JEANS WAY SUBDIVISION, **RESUBDIVISION OF LOTS 1 & 2**

APPLICATION NUMBER 5 DATE April 5, 2007
APPLICANT Jean's Way Subdivision, Resubdivision of Lots 1 & 2
REQUEST Subdivision

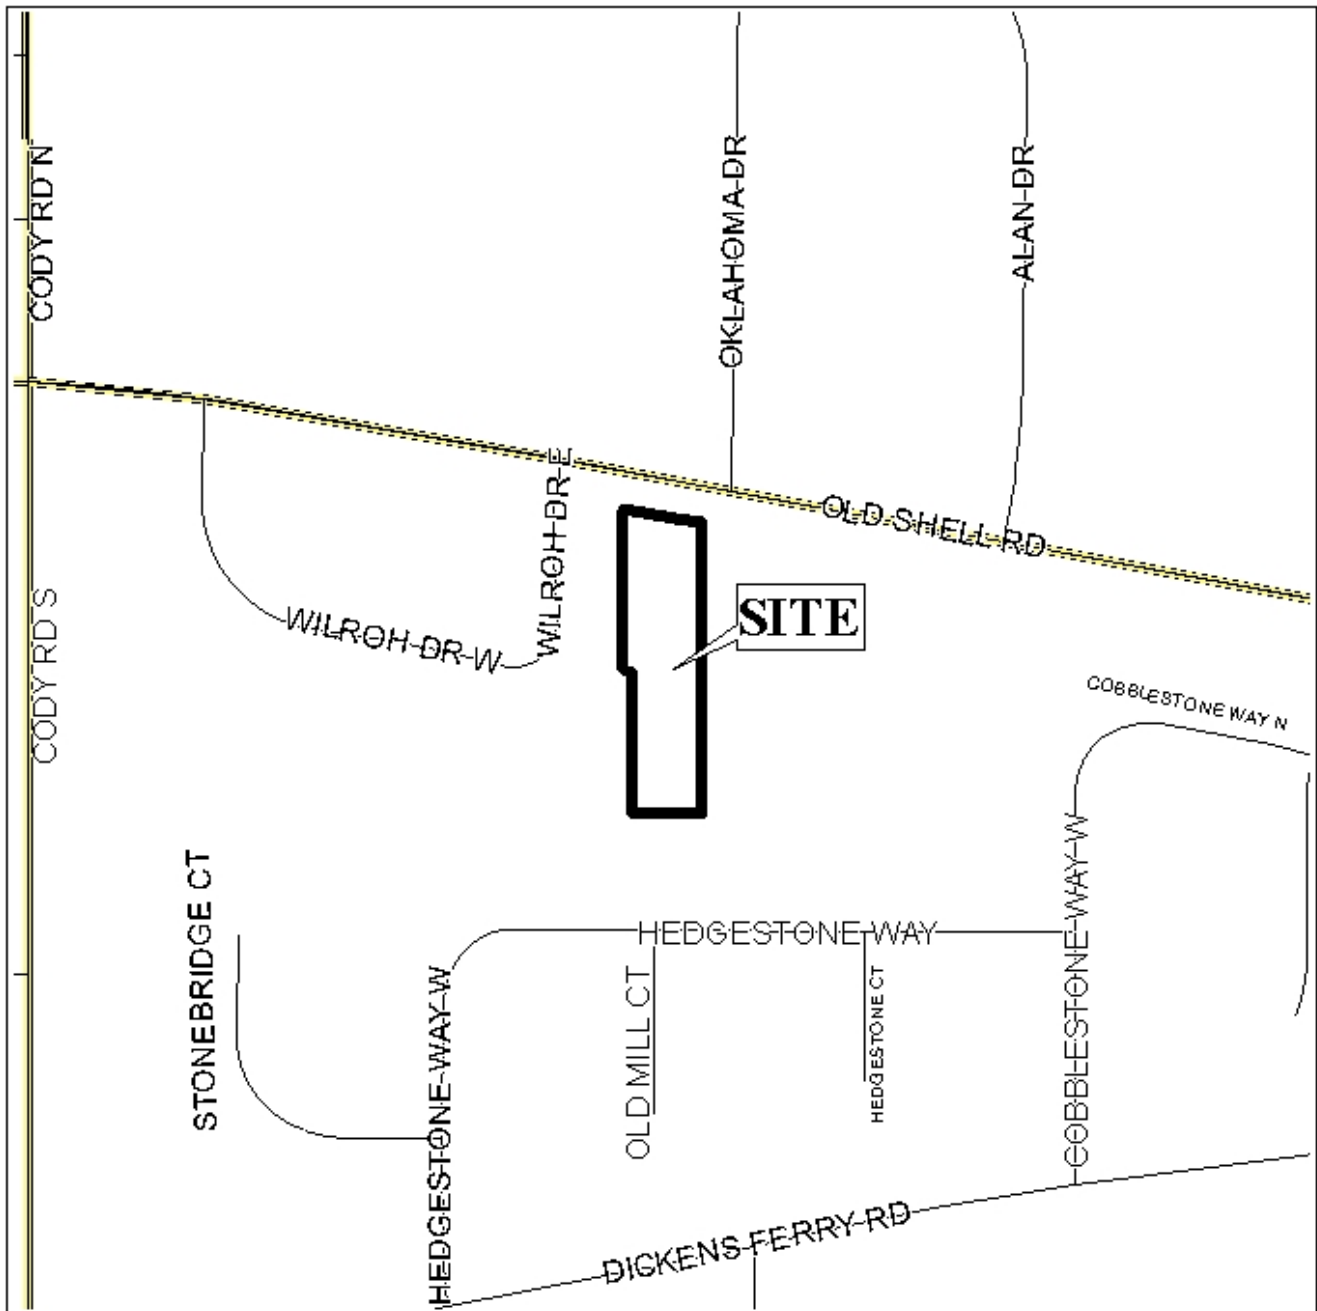
However, the building setback line for Lot 2 is inaccurately depicted on the preliminary plat. It is shown as being 25' from the Old Shell Road property line (as was erroneously approved on the previous plat). The subdivision Regulations require that the lot be at least 60' wide at the building setback line, thus the setback line must be moved such that it is 25' from the point where the "flag-pole" ends.

1. Each lot be limited to one curb cut each to Old Shell Road, size, location and design to be approved by Traffic Engineering and ALDOT (as noted on the preliminary plat submitted); and
2. Revision of the setback line for Lot 2 to be 25' from the terminus of the "flag-pole", as is standard for flag shaped lots.
